11302, 11306, 11308, 11312, 11316, 11320, 11322 and 11326 - 79 Street NW; 11303, 11305, 11307, 11311, 11315, 11317, 11321 and 11323 - 80 Street NW; and 7300 - 116 Avenue NW
Position of Administration: Support

Bylaw 21234 proposes a rezoning from the Urban Facilities Zone (UF) and the Medium Scale Residential Zone (RM h16.0) to the Public Utility Zone (PU) to allow for the development of stormwater management facilities (SWMFs). Charter Bylaw 21232 proposes an amendment to the North Central District Plan to facilitate the proposed rezoning. Bylaw 21233 proposes an amendment to the Exhibition Lands Planning Framework (ELPF) to facilitate the proposed rezoning.

Exhibition Lands Planning Framework (ELPF) Summary of Proposed Amendments

Exhibition Lands Planning Framework Proposed Figure Amendments

Proposed Map 3: Nodes and Corridors

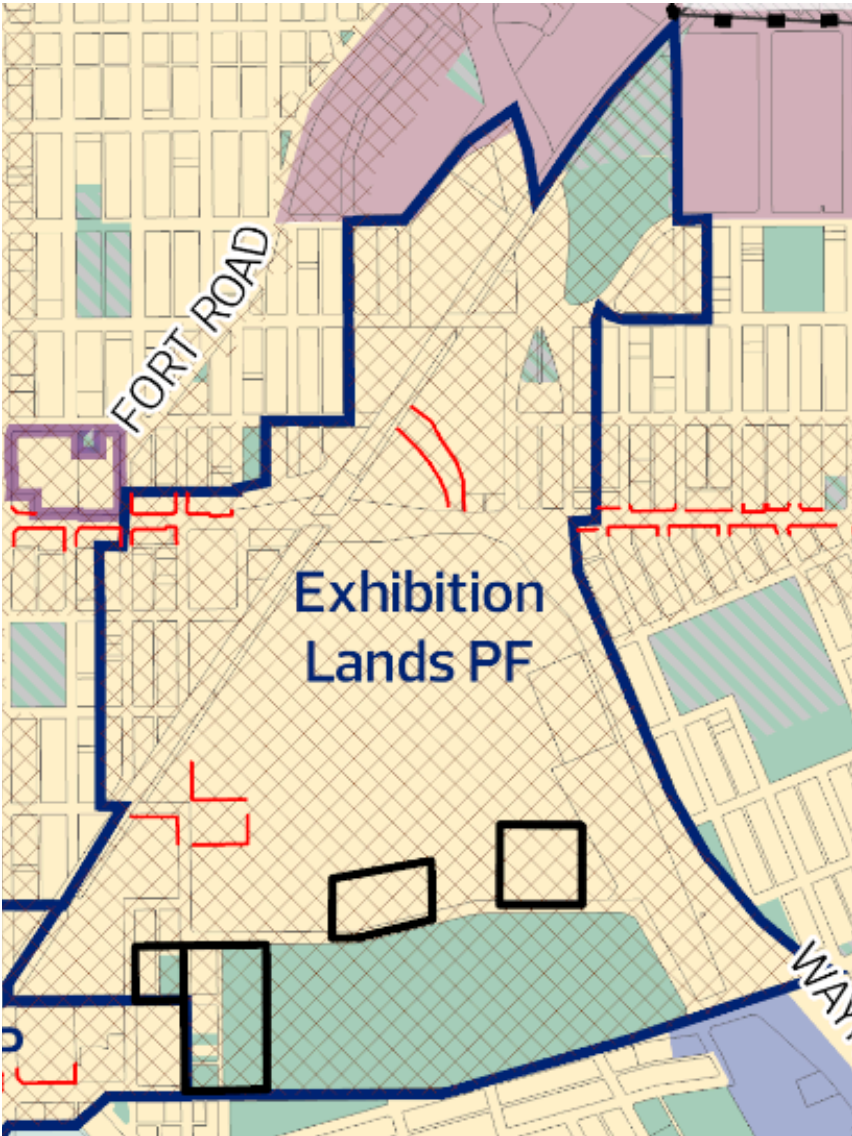
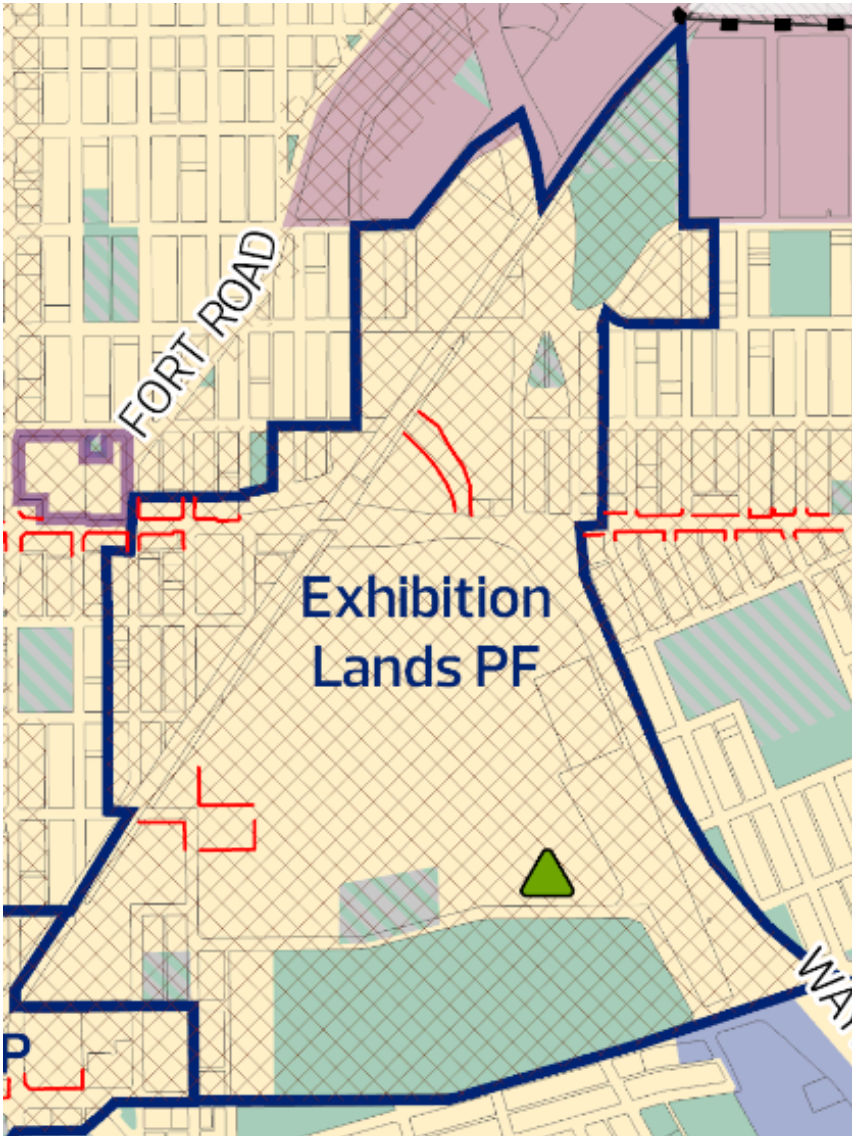
- Map 1: Heritage and Culture, Map 2: Activating Growth to 1.25 Million, and Map 3: Nodes and Corridors: remove the 'open area' designation.
- Map 4: Land Use Concept to 1.25 Million: redesignate from 'urban mix' and 'open space - current' to 'urban service'.
- Map 5: Open Space and Natural Areas to 1.25 Million: remove 'special purpose facility' designation.

Proposed Map 4: Land Use Concept to 1.25 Million

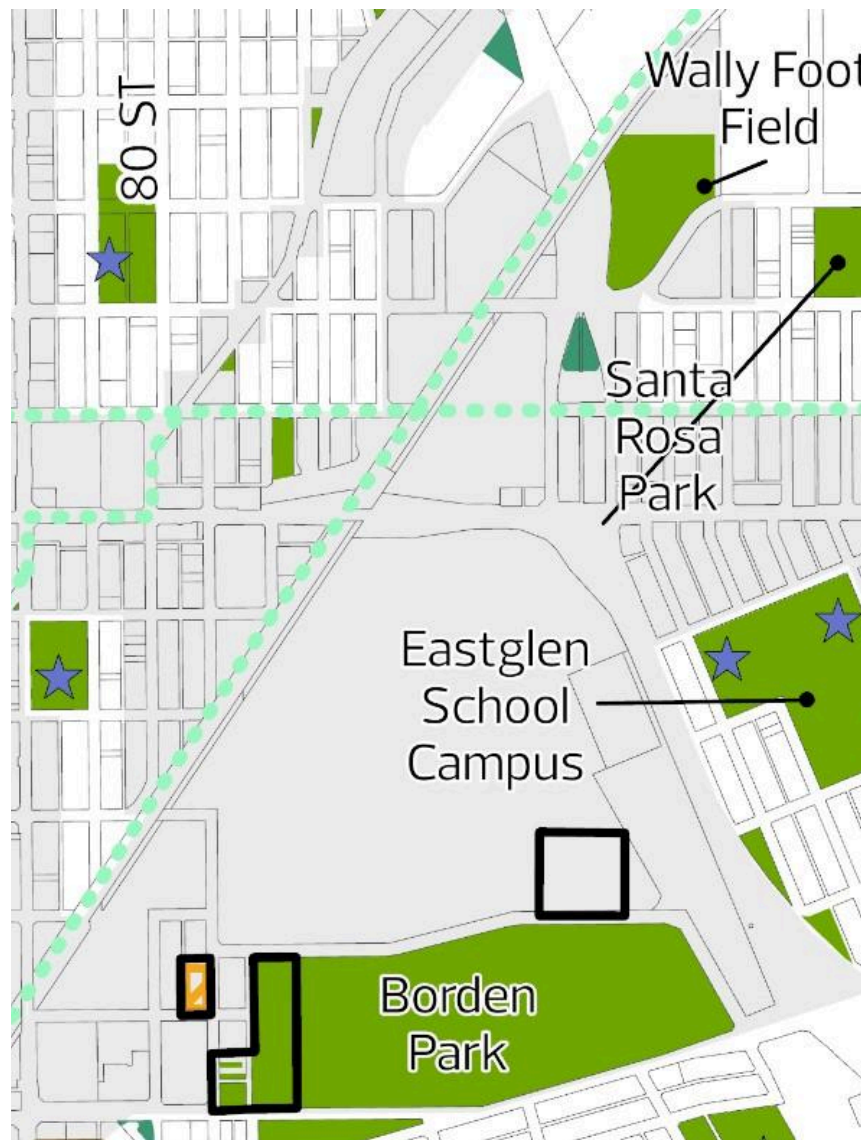
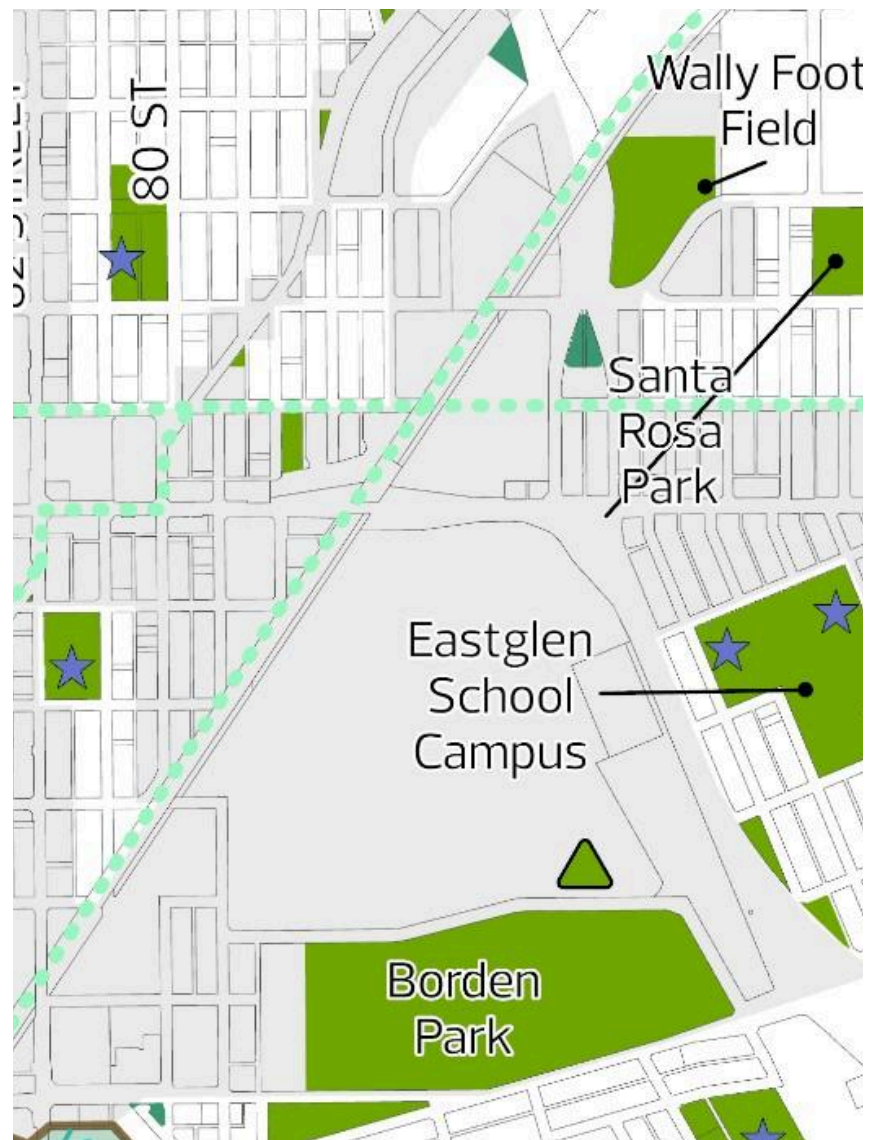
In the Exhibition Lands Planning Framework (ELPF), an expansion to Borden Park is proposed. A 'medium - planned municipal park' icon has been added to Maps 2, 4, and 5 to reflect this.
